EPC STORMWATER REVIEW COMMENTS ARE
SHOWN IN ORANGE BOXES WITH BLACK TEXT

The Cottages at Mesa Ridge Final Drainage Report

April 2022

PCD File No. PUDSP2111

STREET CAPACITY - APISHAPA HEIGHTS W/ BASIN 1 FLOW (Q100 = 15.0)

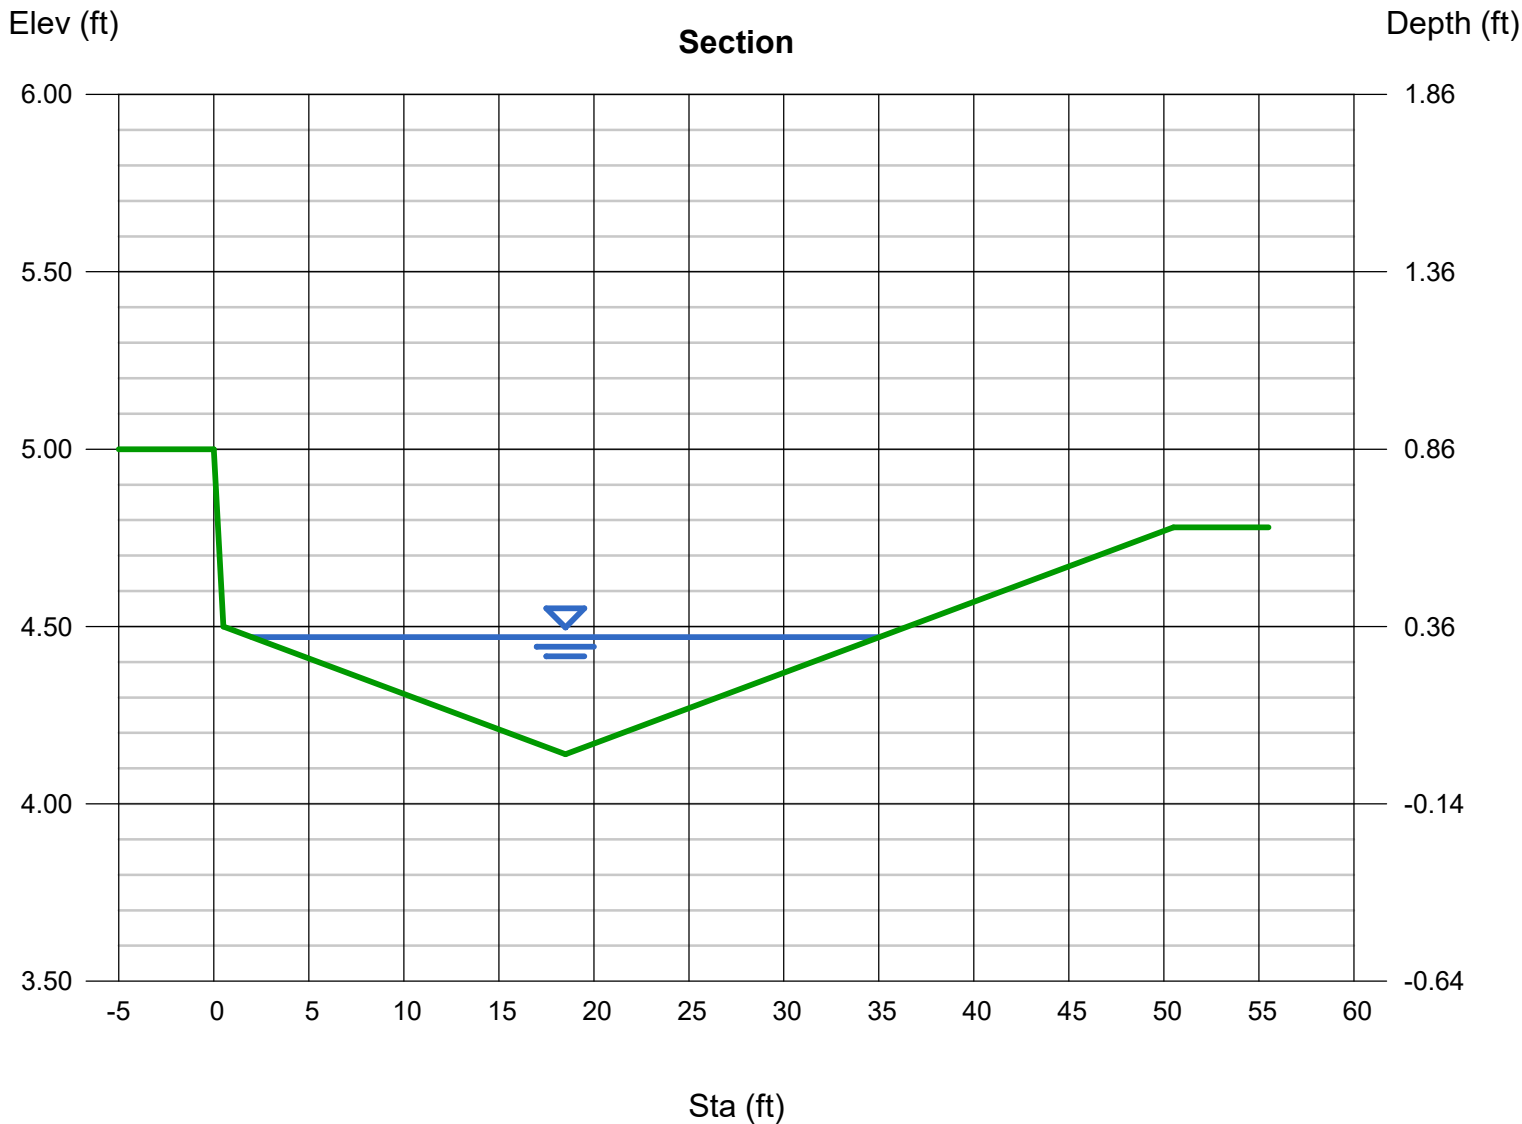
DP2 is located at the existing Box culvert. Should this be DP1 or basin 2? Please clarify/revis accordingly .

HR GREEN:
ADDRESSED, DP1
IS CORRECT.

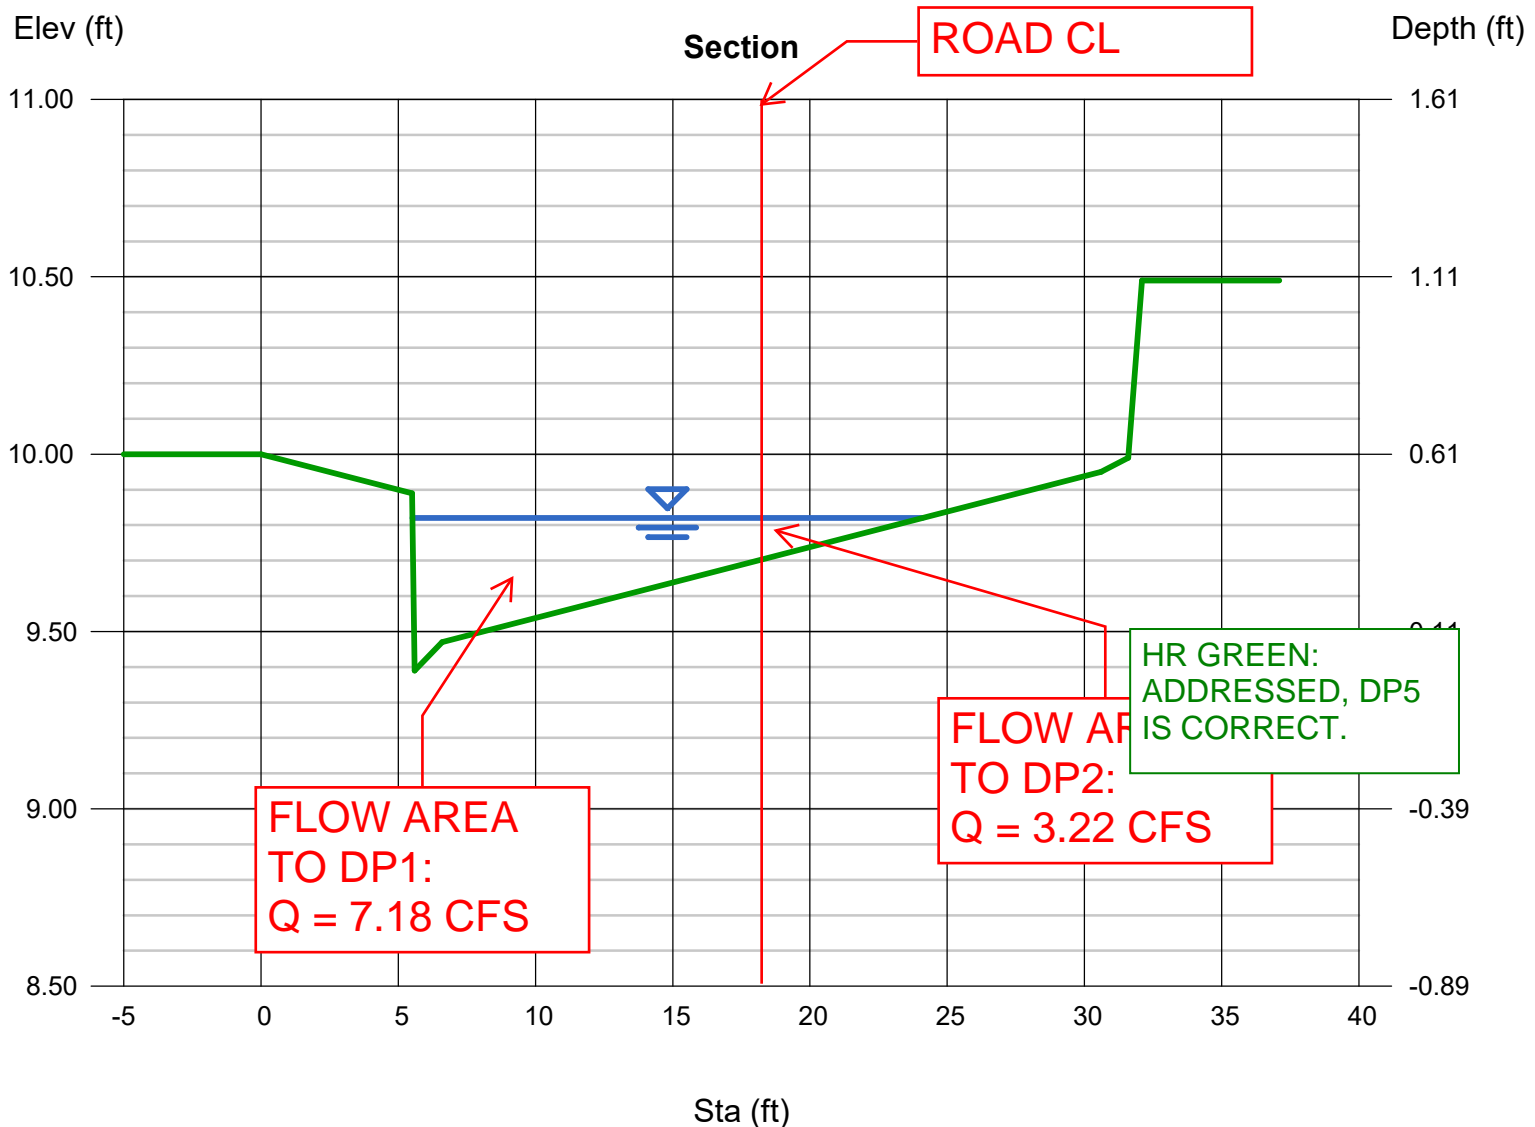
Hydraflow Express Extension for Autodesk® Civil 3D® by Autodesk, Inc. see comment above and revise any other sheets as necessary

HR GREEN:
ADDRESSED, DP1
IS CORRECT.

FlexTable: Conduit Table

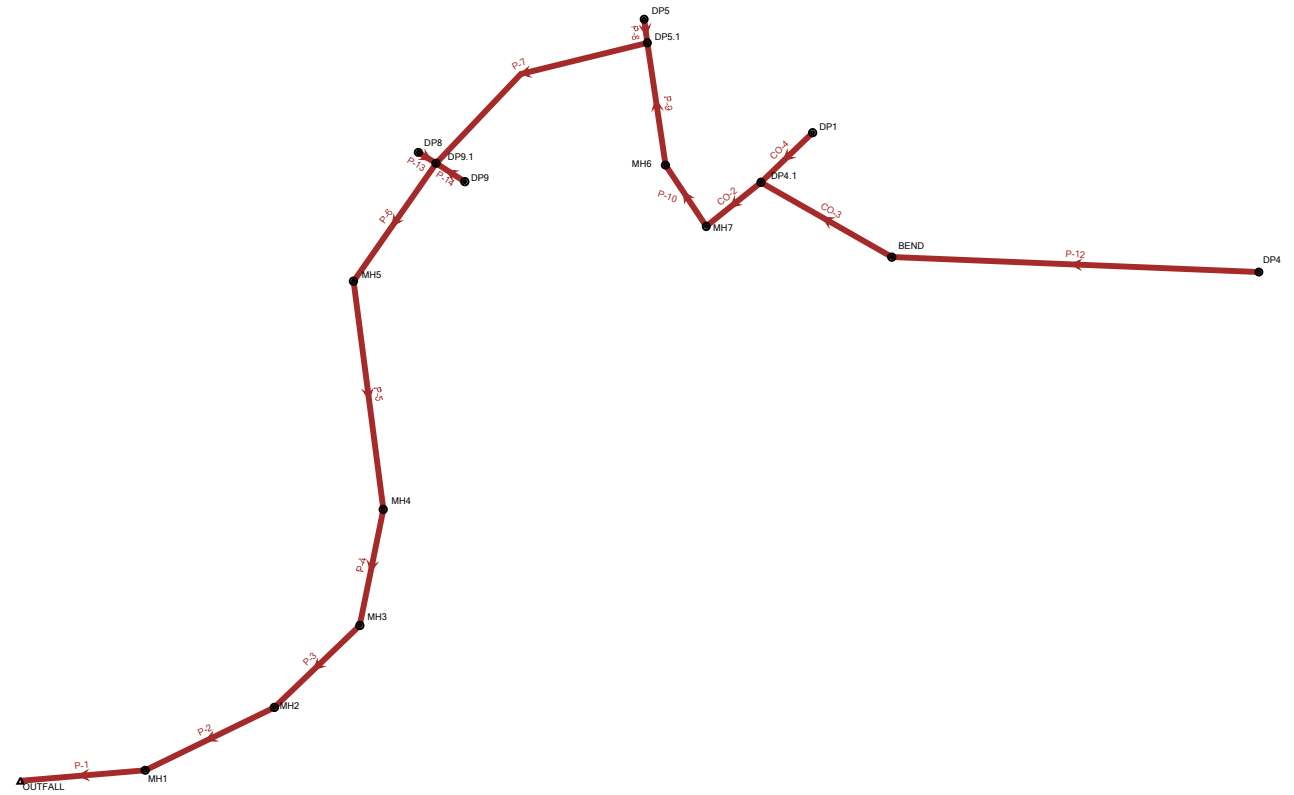
please provide label that
this is the 100yr
analysis.

HR GREEN:
ADDRESSED.
MAJOR AND
MINOR STORM
LABELS ADDED
TO ALL
STORMCAD
APPENDIX
MATERIAL.

DETENTION BASIN OUTLET STRUCTURE DESIGN

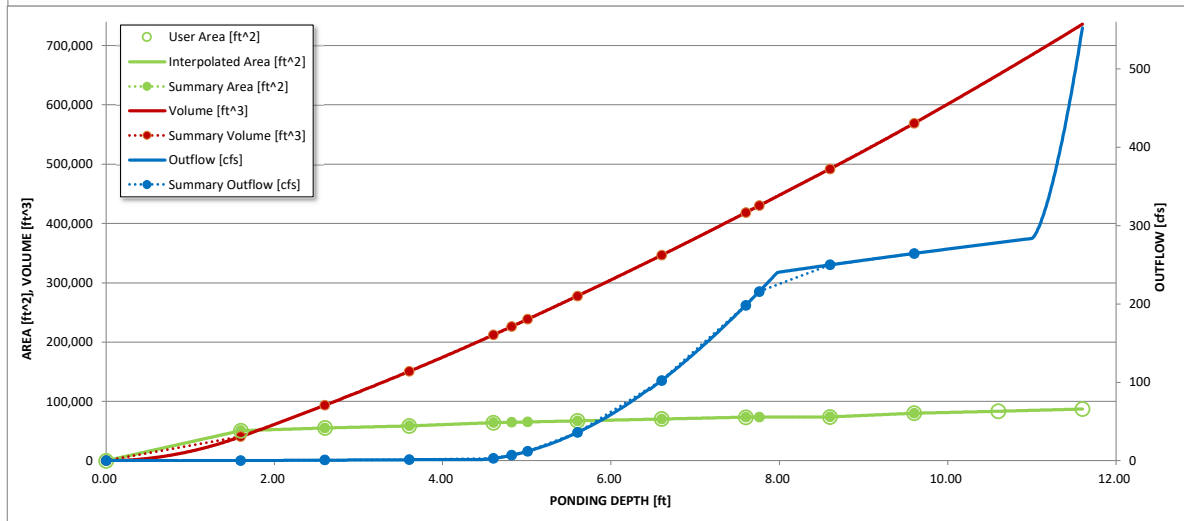
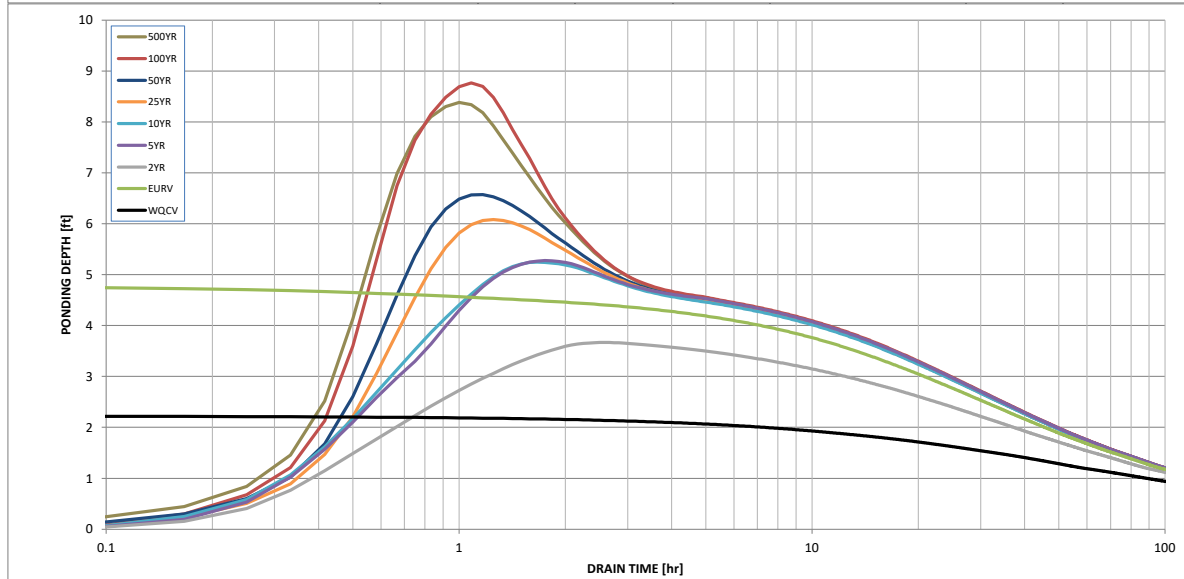
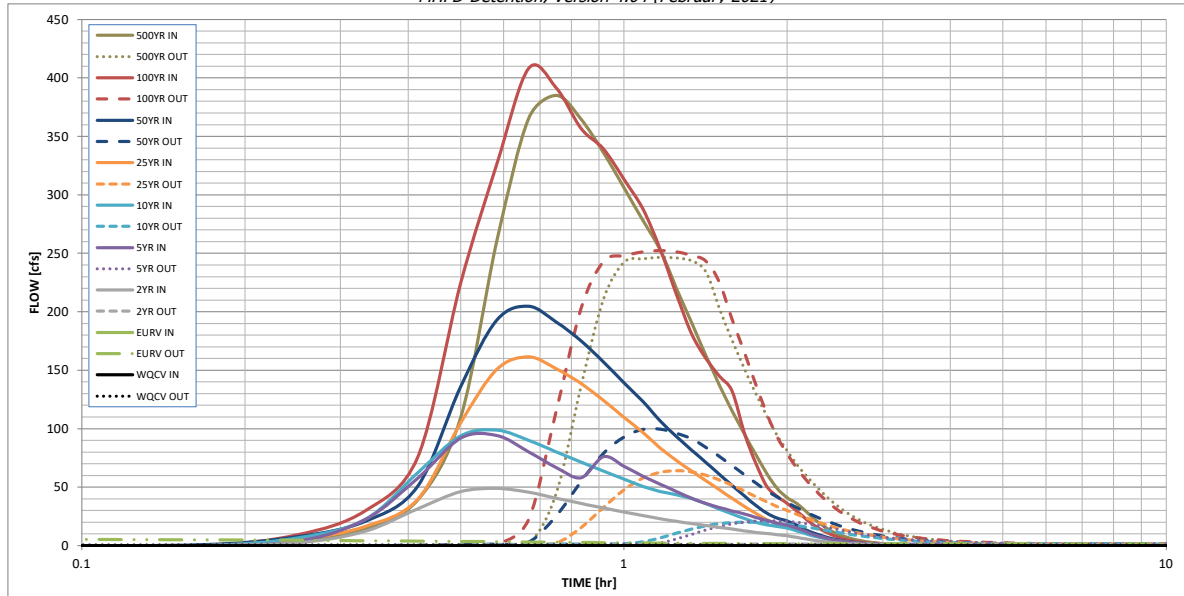
This does not match the orifices shown on the modified orifice plate on the CD's as it still shows the existing nine rows. Please revise accordingly so that they match.

HR GREEN:
ADDRESSED
OUTLET
STRUCTURE
DETAIL HAS
BEEN UPDATED
AND REFLECTS
UD-DETENTION
AS SHOWN
